Subject: Base Support Building Solid Waste Management Unit (SWMU) No. 014
PlumeStop[®] Pilot Study Work Plan, Kennedy Space Center (KSC), Florida

**BASE SUPPORT BUILDING (SWMU 014) PLUMESTOP® INJECTION
PILOT STUDY WORK PLAN
KENNEDY SPACE CENTER, FLORIDA**

Subject: Response to Comments on PFAS Site Assessment and Mitigation – PlumeStop® Injection Pilot Study Work Plan Base Support Building (Formerly Maintenance & Operations Building) ADP

Groundwater elevation data collected by HydroGeoLogic in April 2023.
Figure created by AECOM in August 2023.

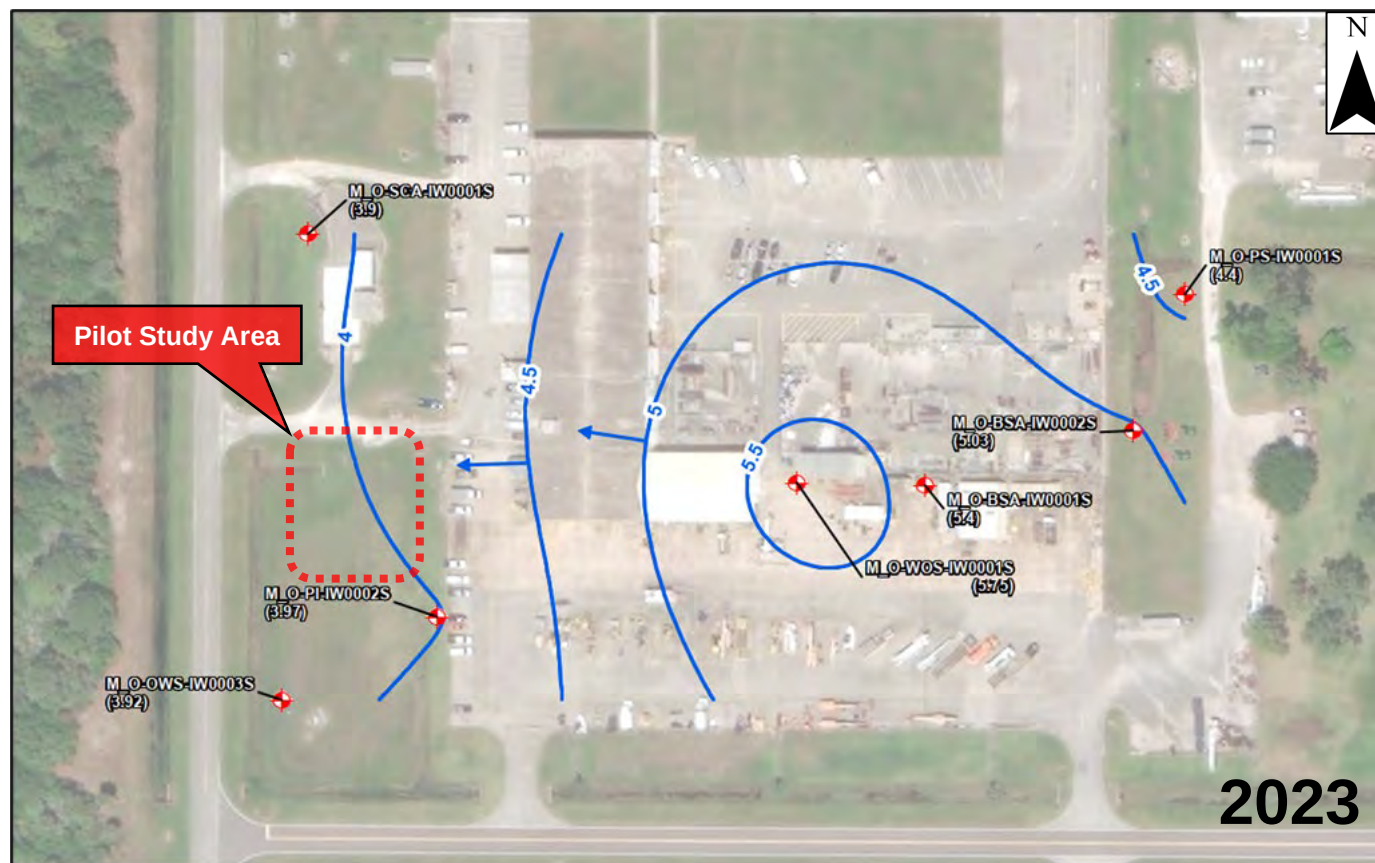
- HGL Comment #2: Slide 13: Groundwater elevations are available for additional wells surrounding the Base Support Building area. Consider including these wells for contouring flow directions. Using additional data seems to indicate that there is a groundwater flow divide located in this area where flow is either northwest towards SMWU 118 (like in 2002 or to the southwest, coinciding with the ditch along A Ave SE). The primary plume axis for PFAS appears to follow the northwest flow direction. Verification of the shallow groundwater flow direction described on pages 17 and 18 should help to better define the flow direction through the proposed PRB.

- *Response: AECOM requests the data referenced to be shared. This data will be reviewed prior to implementation of the scope of work.*
- Tetra Tech Comment #1: Slide 13/15 – Please clarify if groundwater flow direction below 13.5 feet bls the same as the 3.5-13.5 feet bls interval. It is implied on Slide 15 but not clearly specified.

- *Response: The monitoring wells utilized for the potentiometric surface maps range in depth from 3.5 to 14 feet bls and have exhibited variable GW flow directions across the site. The intermediate (20-25ft) and deep (35-40ft) zones have had more uniform contour lines and typically exhibit a similar GW flow direction as the shallow zone near the pilot study area.*

Design Summary

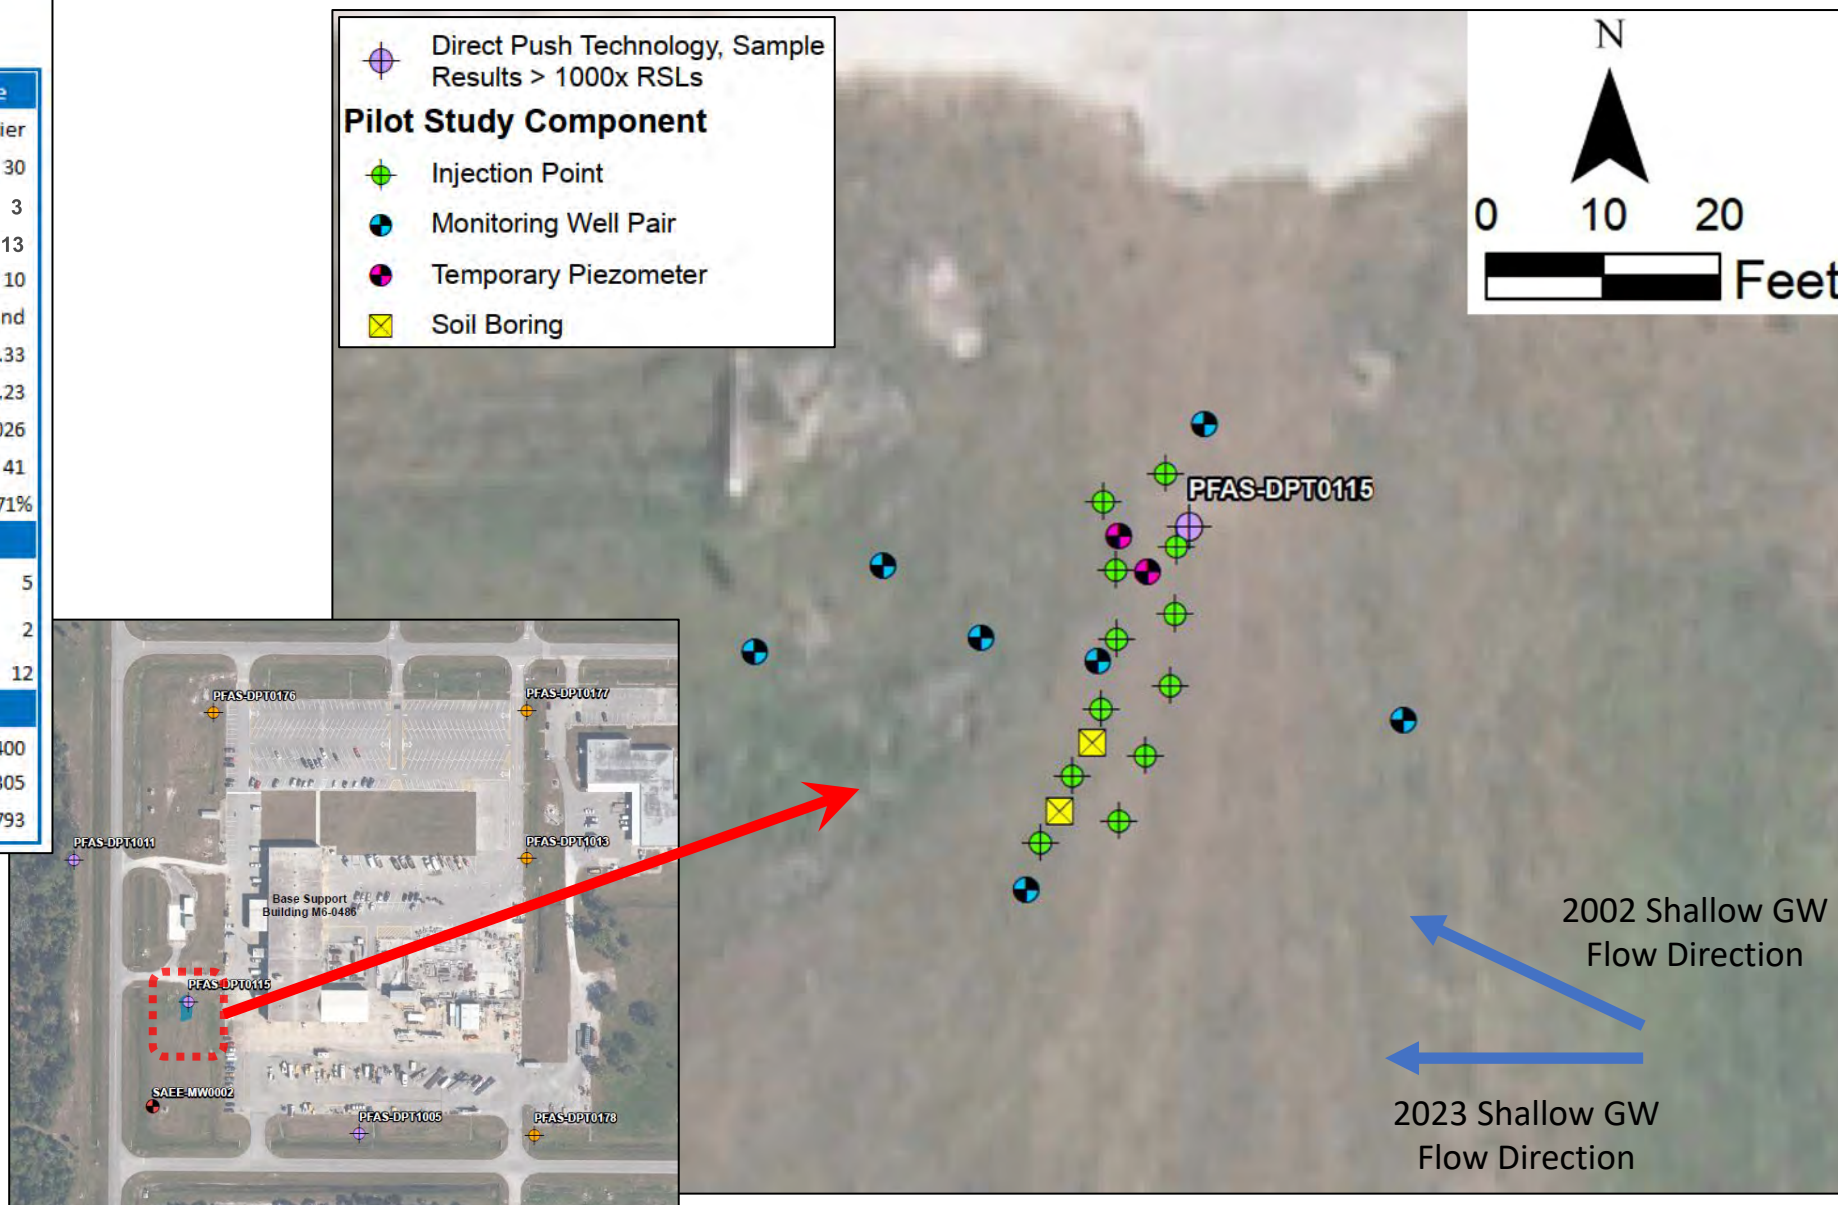
- HGL Comment #3: Slide 14. Seepage velocity is 82.5 ft/yr based on hydraulic conductivity of 20 ft/day (7300 ft/yr x .0026 ft/ft)/.23 = 82.5 ft/yr. High seepage velocity (82.5 ft/yr, or 41 ft/yr as in ADP) plus quartz sand aquifer means it is possible that the PlumeStop will be actively transported rather than acting as a “fixed” barrier. Please address that possibility.

- Tetra Tech Comment #2: Slide 14 – Spacing within rows (5 feet) is listed on the design summary. Specify the spacing between the two rows and the basis for the estimated radius of influence for each injection

- Tetra Tech Comment #3: Slide 14 – Please provide the basis for the PlumeStop dosage of 367 lbs per injection point.
- *Response: The dosage was recommended by Regenesi as a typical value based on their application experience.*

- *Response: This question was posed to Regenesi, the supplier of PlumeStop. Their reply is as follows:*
“For the proposed KSC pilot the 7 cm/day (83 ft/yr) seepage would normally not be a concern. A sediment sieve-analysis is useful in predicting any unwanted advection. With the pre-emptive application of a divalent cation solution (i.e. calcium chloride) the carbon set-up can be accelerated to ‘park’ the PlumeStop in the intended target treatment zone.” Grain size analyses will be performed prior to injection of the PlumeStop. If excessive advection is suspected as a result of these grain size analyses, the application of a calcium chloride solution will be considered.

- *Response: The spacing between the rows is approximately 5 feet. The radius of influence was recommended by Regenesi as a commonly observed value based on their application experience.*

Conceptual Model – Side View

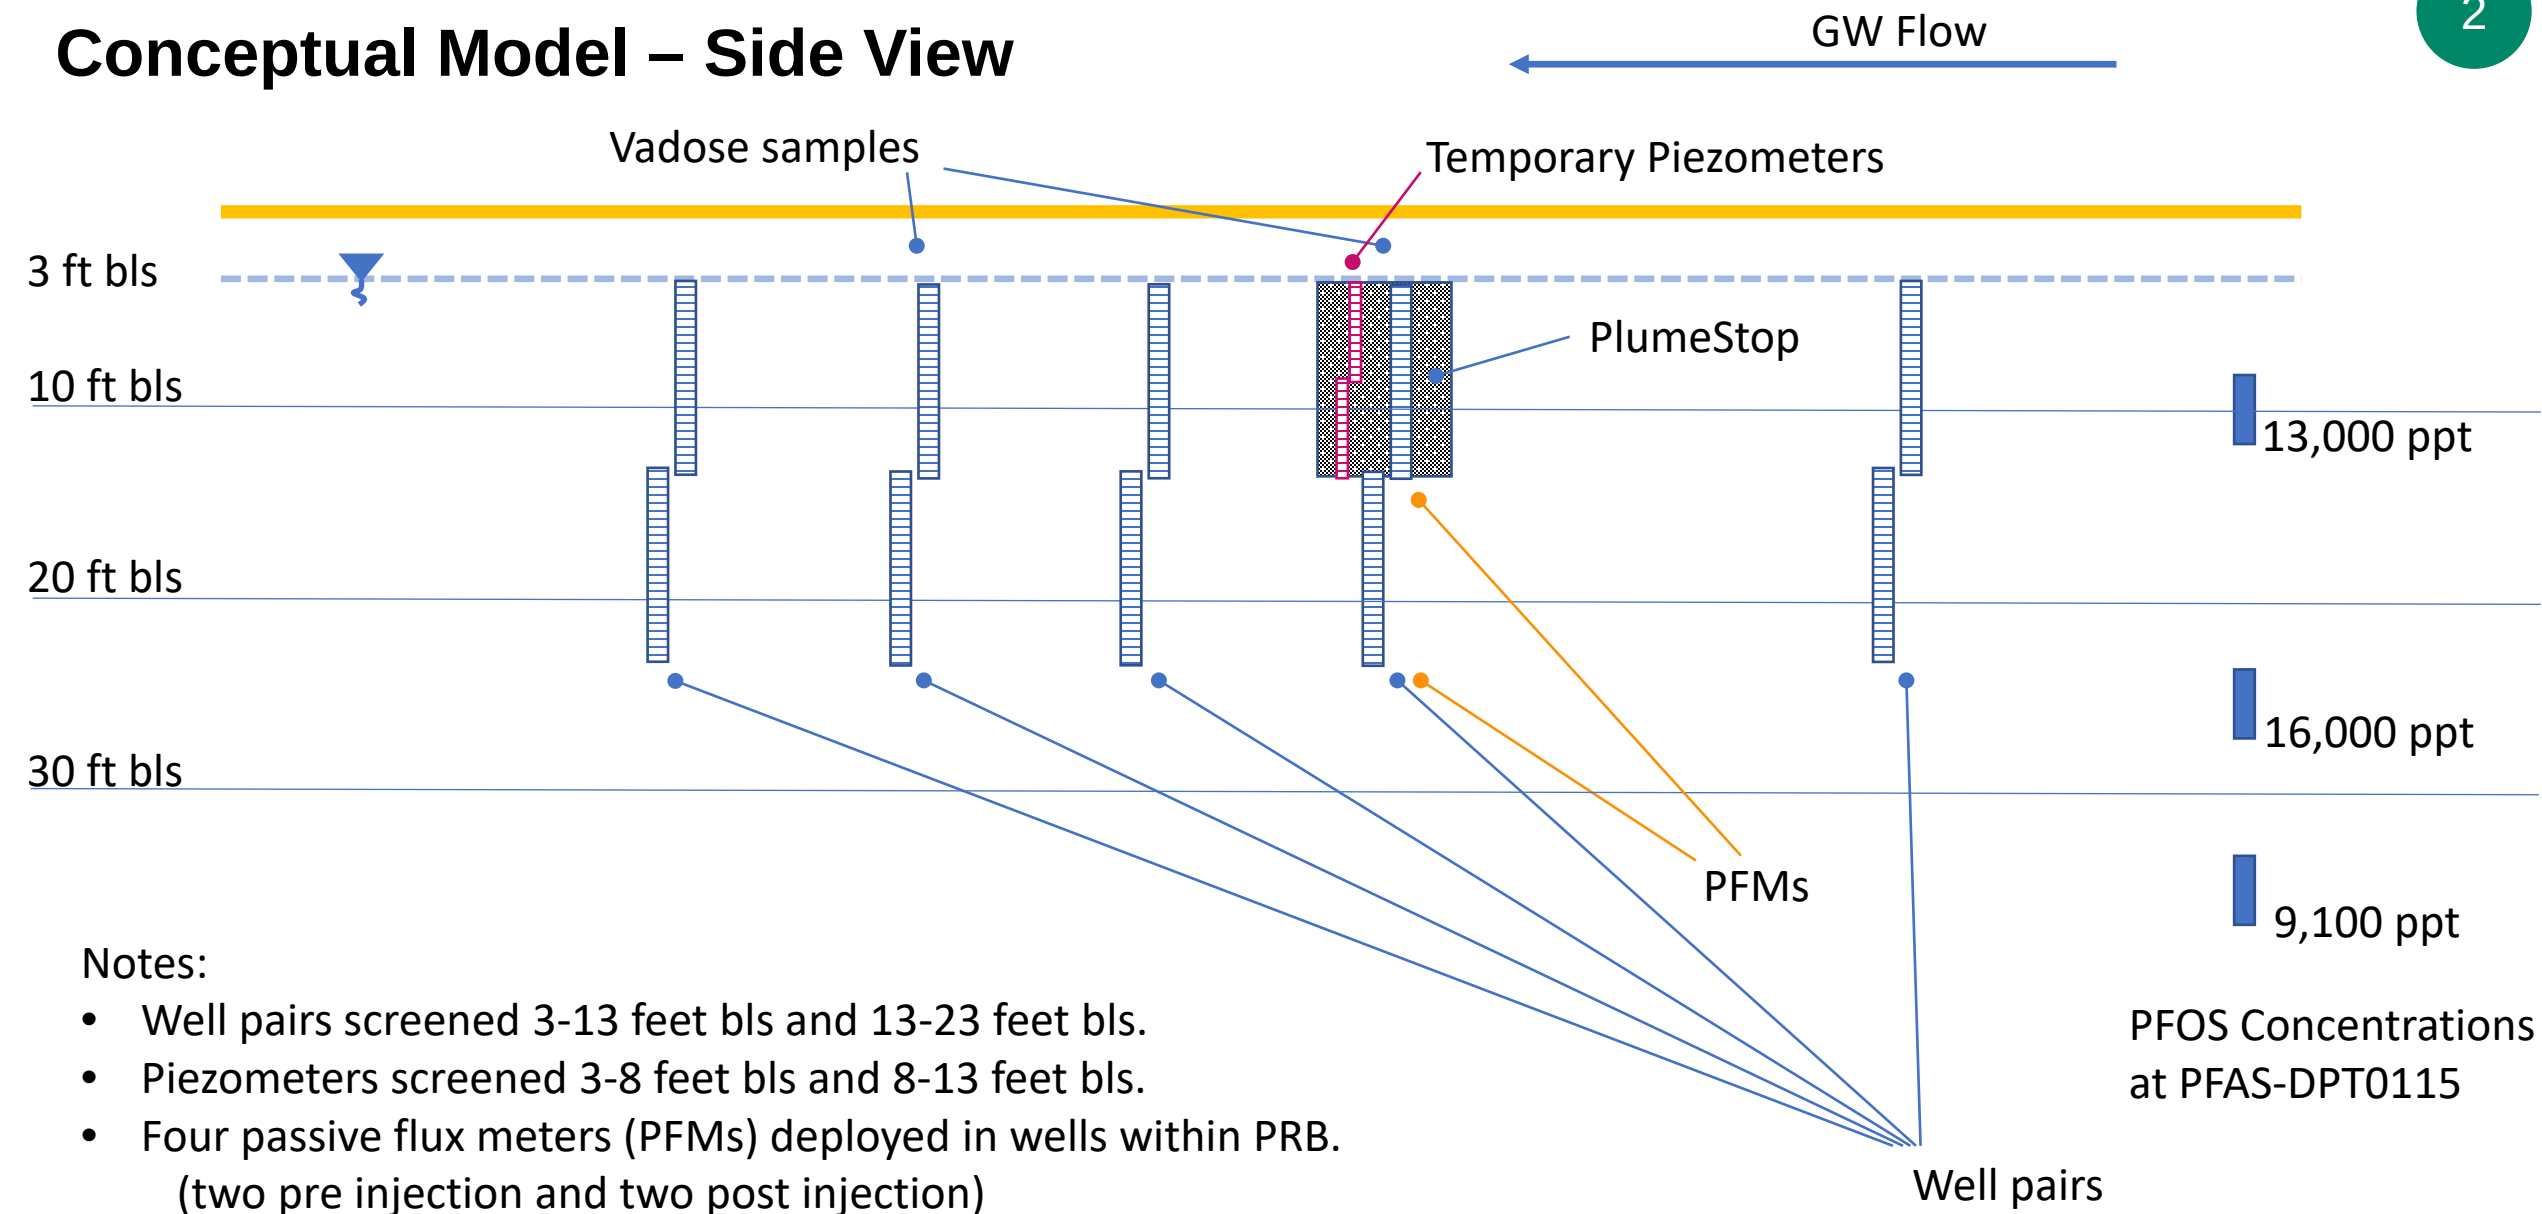
- HGL Comment #4: Slides 14 and 15: The plan view on page 14 shows two soil boring locations within the downgradient injection line, but the cross-section on page 15 shows one soil sample location within the PRB alignment and the second one downgradient of the PRB. Please resolve this apparent inconsistency between the two slides.
- *Response: The yellow soil borings are to be deployed during the Placement Validation activities, described on Slide 22. The 50 foot soil core will be collected during installation of the monitoring well within the barrier alignment. Vadose zone soil samples will be collected during installation of monitoring wells within, and downgradient of the PRB.*
